**STAFF REPORT**  
(Preliminary Plat Deferred from 7/8/99)

**CASE NUMBER:** S/D 99-41 - SMITHMOOR COMMERCIAL ADDITION

**STAFF REPORT**  
(Final Plat, Preliminary Plat Approved 8/5/99)

STAFF REPORT

VICINITY MAP

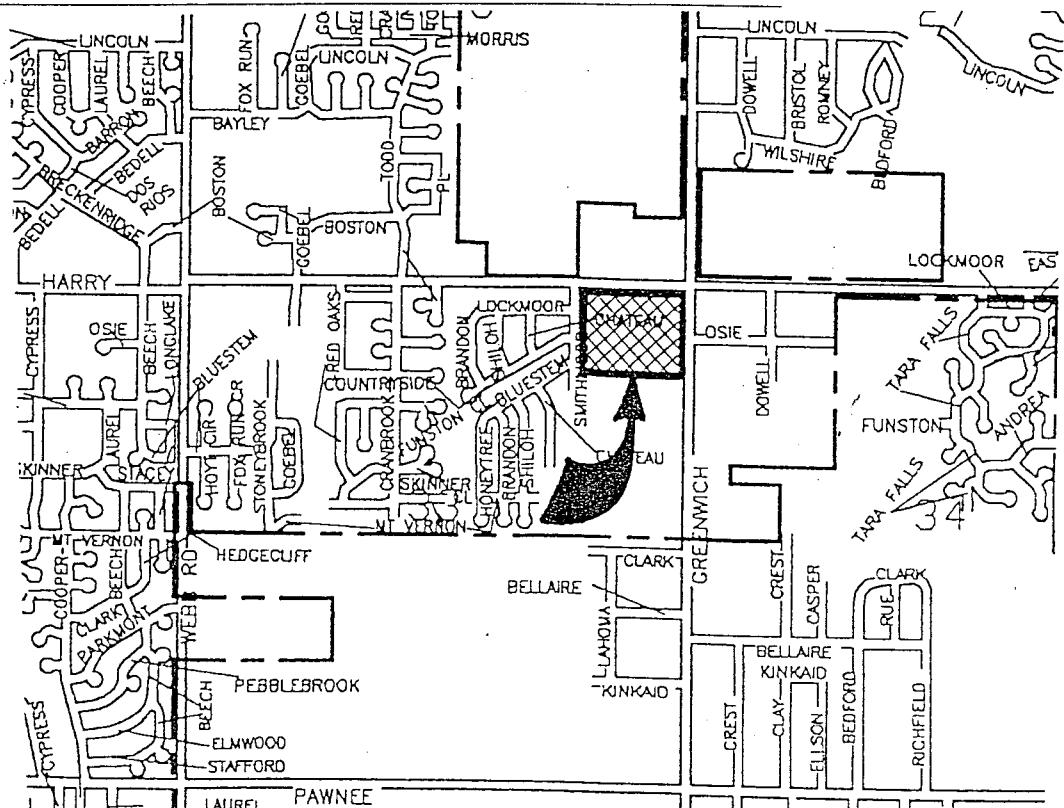
- A. The applicant shall guarantee the extension of sanitary sewer to serve the lots being platted. This guarantee shall be with the County for service through the Four Mile Creek sanitary sewer system. On the final plat tracing, appropriate wording shall be added to the Mayor's signature block indicating the City's agreement to allow a County sewer district to be formed within the City.

- B. The applicant shall guarantee the extension of City water to serve the site.
- C. If improvements are guaranteed by petition, a notarized certificate listing the petitions shall be submitted to the Planning department for recording.

- D. City Engineering needs to comment on the status of the applicant's drainage concept.
- E. Traffic Engineering needs to comment on the access controls. The access controls coincide with those proposed for the CUP. The plat denotes two access openings along Greenwich and three access openings along Harry. Distances shall be shown for all segments of access control. The plat's text shall reference the access controls. The proposed access easement needs to be established by separate instrument.

- F. The wall easement shall be referenced in the plat's text.
- G. The applicant shall submit a copy of the instrument which establishes the pipeline easements on the property, which verifies that the easements shown are sufficient and that utilities may be located adjacent to and within the easements.

- H. The setback from the pipeline easement shall be indicated as a building setback line for the Williams Pipeline.
- I. The bearings need to be included on the final tracing.

- J. The final plat shall reference a tie point to a section corner.
- K. Traffic Engineering needs to comment on the need for improvements to Harry or Greenwich. Traffic Engineering has required right turn lanes for the access points on Harry and Greenwich, left turn lanes for all major access openings on Harry and Greenwich, and 12.5% of the signalization cost at the Harry and Greenwich intersections.

- L. Traffic Engineering needs to comment on the need for additional right-of-way along Harry.
- M. The platlor's text on the final plat needs to reference the wall easement.

- Q. The platlor's text shall include language that a drainage plan has been developed for the plat and that all drainage easements, rights-of-way, or reserves shall remain at established grades or as modified with the approval of the applicable City or County Engineer, and unobstructed to allow for the conveyance of stormwater.

**VICINITY MAP**

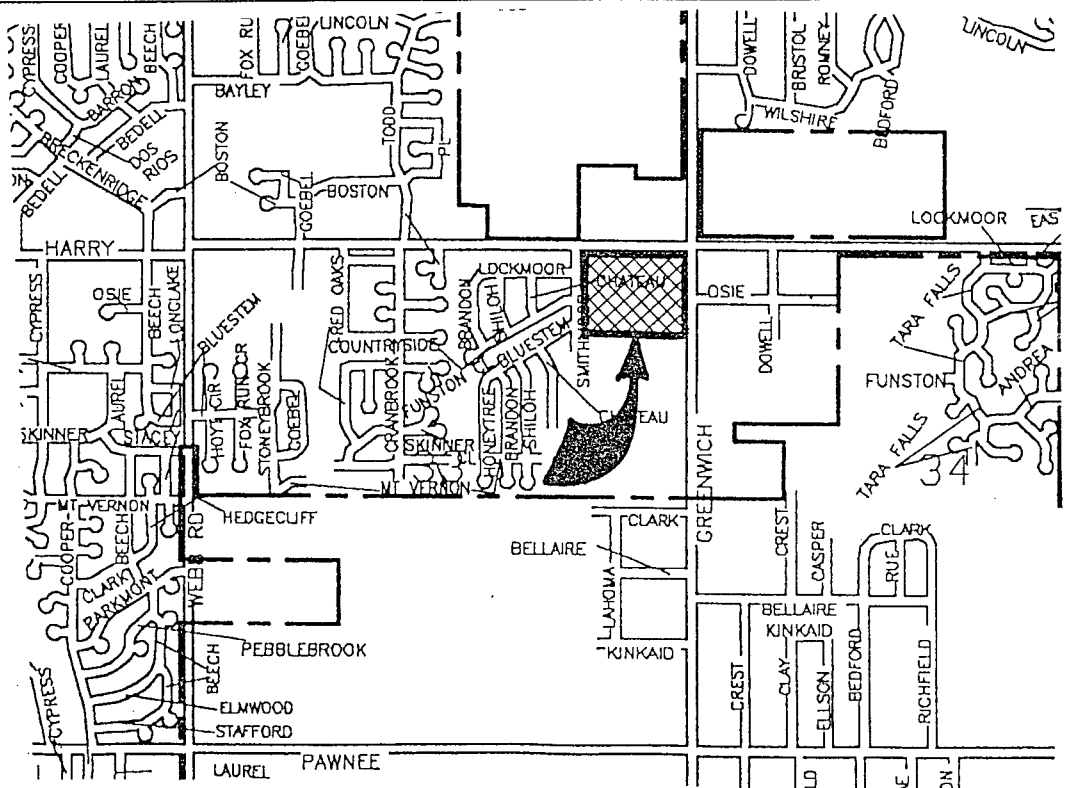
- A. The applicant shall guarantee the extension of sanitary sewer to serve the lots being platted. This guarantee shall be with the County for service through the Four Mile Creek sanitary sewer system. On the final plat tracing, appropriate wording shall be added to the Mayor's signature block indicating the City's agreement to allow a County sewer district to be formed within the City.

- B. The applicant shall guarantee the extension of City water to serve the site.
- C. If improvements are guaranteed by petition, a notarized certificate listing the petitions shall be submitted to the Planning department for recording.

- D. **City Engineering** needs to comment on the status of the applicant's drainage concept.
- E. **Traffic Engineering** needs to comment on the access controls. The access controls should coincide with those approved for the proposed CUP. The plat proposes two access openings along Greenwich and four access openings along Harry. Distances shall be shown for all segments of access control. The plat's text shall reference the access controls. Proposed cross-lot access easement need to be established by separate instrument.

- G. The wall easement shall be referenced in the plat's text.
- H. The applicant shall submit a copy of the instrument which establishes the pipeline easements on the property, which verifies that the easements shown are sufficient and that utilities may be located adjacent to and within the easements.

- I. The applicant's agent shall determine any setback requirements for the pipelines by researching the text of the pipeline agreements. If a setback from the pipeline easements is provided for in the pipeline easement agreements, it shall be indicated on the face of the plat.

- J. The bearings need to be included on the final tracing.
- K. The final plat shall reference a tie point to a section corner.
- L. **Traffic Engineering** needs to comment on the need for improvements to Harry or Greenwich.

- N. A CUP Certificate shall be submitted identifying the approved CUP and its special conditions for development on the property.
- O. The access easement along Harry should be included as part of Lot 8 and not referred to as a "reserve". The access easement along Greenwich should be included as part of Lot 11 and not referred to as a "reserve".

- Q. The plat's text shall include language that a drainage plan has been developed for the plat and that all drainage easements, rights-of-way, or reserves shall remain at established grades or as modified with the approval of the applicable City or County Engineer, and unobstructed to allow for the conveyance of stormwater.

VICINITY MAP

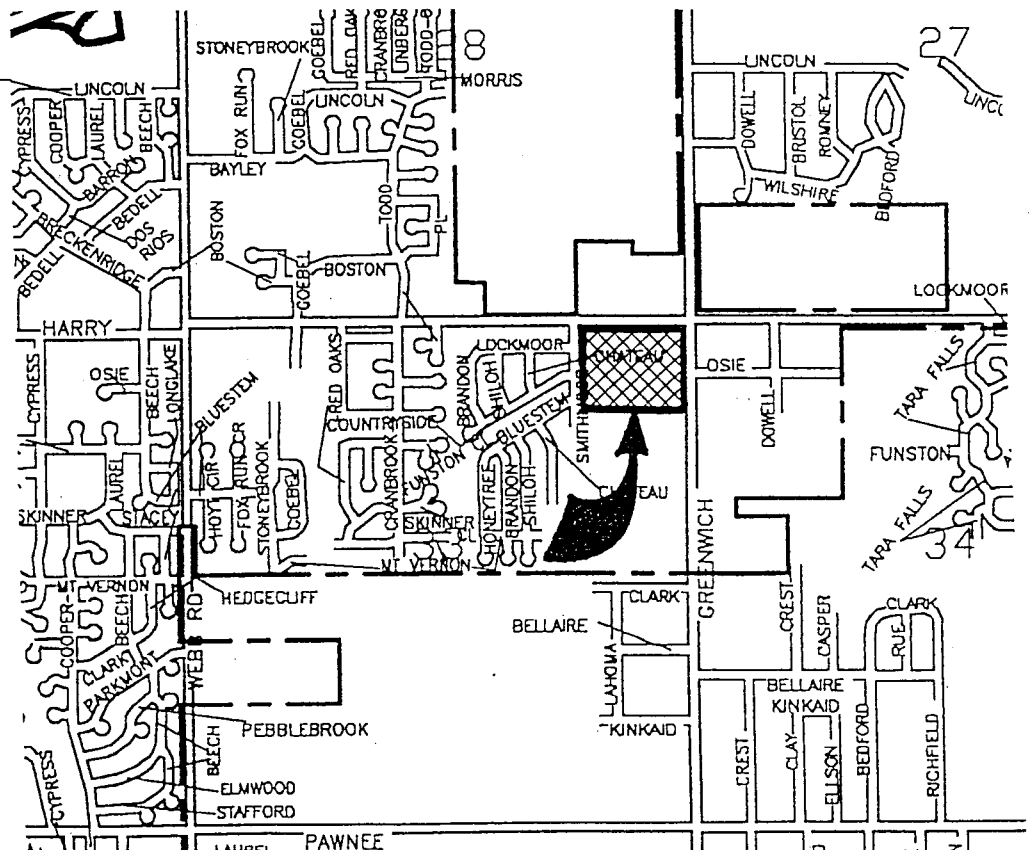
- A. The applicant shall guarantee the extension of sanitary sewer to serve the lots being platted. This guarantee shall be with the County for service through the Four Mile Creek sanitary sewer system. On the final plat tracing, appropriate wording shall be added to the Mayor's signature block indicating the City's agreement to allow a County sewer district to be formed within the City. **A sanitary sewer layout is requested.**

- D. **City Engineering** needs to comment on the status of the applicant's drainage plan. **An off-site drainage agreement is required. A drainage guarantee is required.**

- E. **Traffic Engineering** needs to comment on the access controls. The access controls coincide with those proposed for the CUP. The plat denotes two access openings along Greenwich and three access openings along Harry. Distances shall be shown for all segments of access control. The proposed joint access openings need to be established by separate instrument

- F. The wall easement shall be referenced in the plat's text.
- G. The applicant shall submit a copy of the instrument which establishes the pipeline easements on the property, which verifies that the easements shown are sufficient and that utilities may be located adjacent to and within the easements.

- H. The setback from the pipeline easement shall be indicated as a building setback line for the Williams Pipeline.
- I. The bearings for the tapered right-of-way within Lot 7 need to be included on the final tracing.

- J. The final plat shall reference a tie point to a section corner.
- K. **Traffic Engineering** has required right turn lanes for the access points on Harry and Greenwich, left turn lanes for all major access openings on Harry and Greenwich, and 12.5% of the signalization cost at the Harry and Greenwich intersections.

- L. **Traffic Engineering** needs to comment on the need for additional right-of-way along Harry. **No additional right-of-way is needed.**

VICINITY MAP

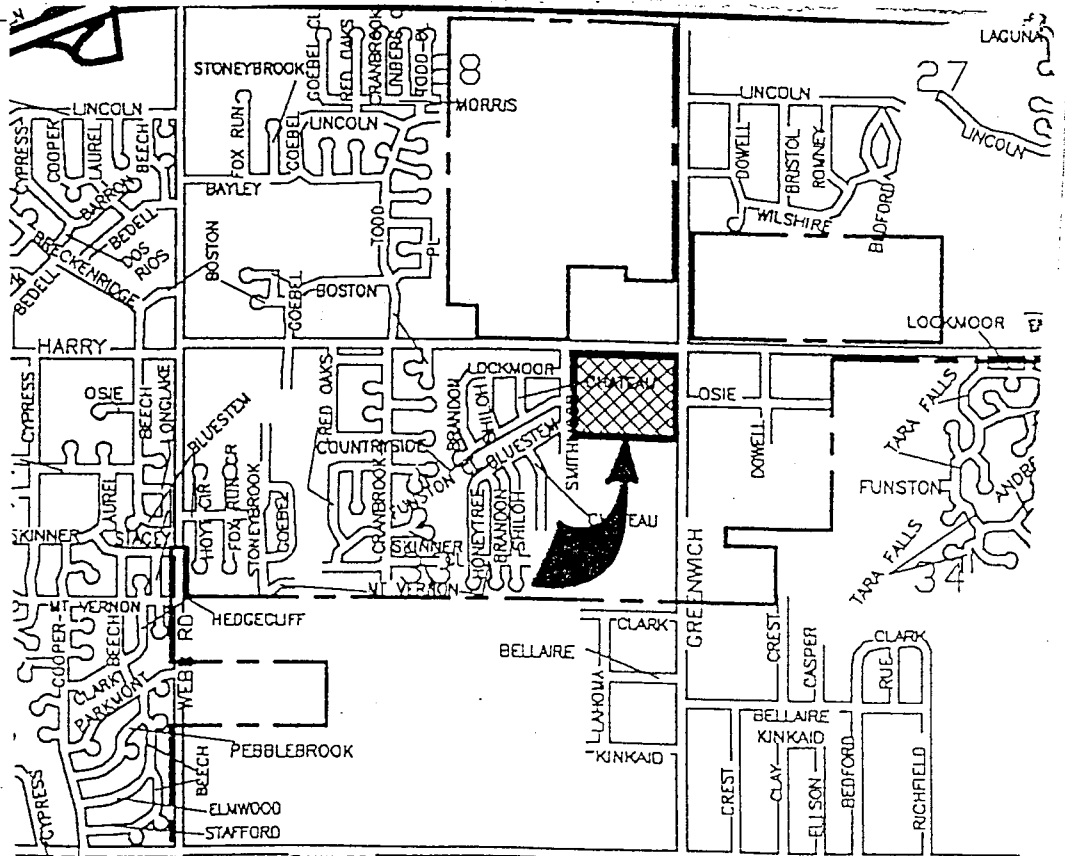
- A. The applicant shall guarantee the extension of sanitary sewer to serve the lots being platted. This guarantee shall be with the County for service through the Four Mile Creek sanitary sewer system. On the final plat tracing, appropriate wording shall be added to the Mayor's signature block indicating the City's agreement to allow a County sewer district to be formed within the City. **A sanitary sewer layout is requested.**

- D. **City Engineering** needs to comment on the status of the applicant's drainage plan. **An off-site drainage agreement is required. A drainage guarantee is required.**

- E. **Traffic Engineering** needs to comment on the access controls. The access controls coincide with those proposed for the CUP. The plat denotes two access openings along Greenwich and three access openings along Harry. Distances shall be shown for all segments of access control. The proposed joint access openings need to be established by separate instrument

- F. The wall easement shall be referenced in the plat's text.
- G. The applicant shall submit a copy of the instrument which establishes the pipeline easements on the property, which verifies that the easements shown are sufficient and that utilities may be located adjacent to and within the easements.

- H. The setback from the pipeline easement shall be indicated as a building setback line for the Williams Pipeline.
- I. The bearings for the tapered right-of-way within Lot 7 need to be included on the final tracing.

- J. The final plat shall reference a tie point to a section corner.
- K. **Traffic Engineering** has required right turn lanes for the access points on Harry and Greenwich, left turn lanes for all major access openings on Harry and Greenwich, and 12.5% of the signalization cost at the Harry and Greenwich intersections.

- L. **Traffic Engineering** needs to comment on the need for additional right-of-way along Harry. **No additional right-of-way is needed.**
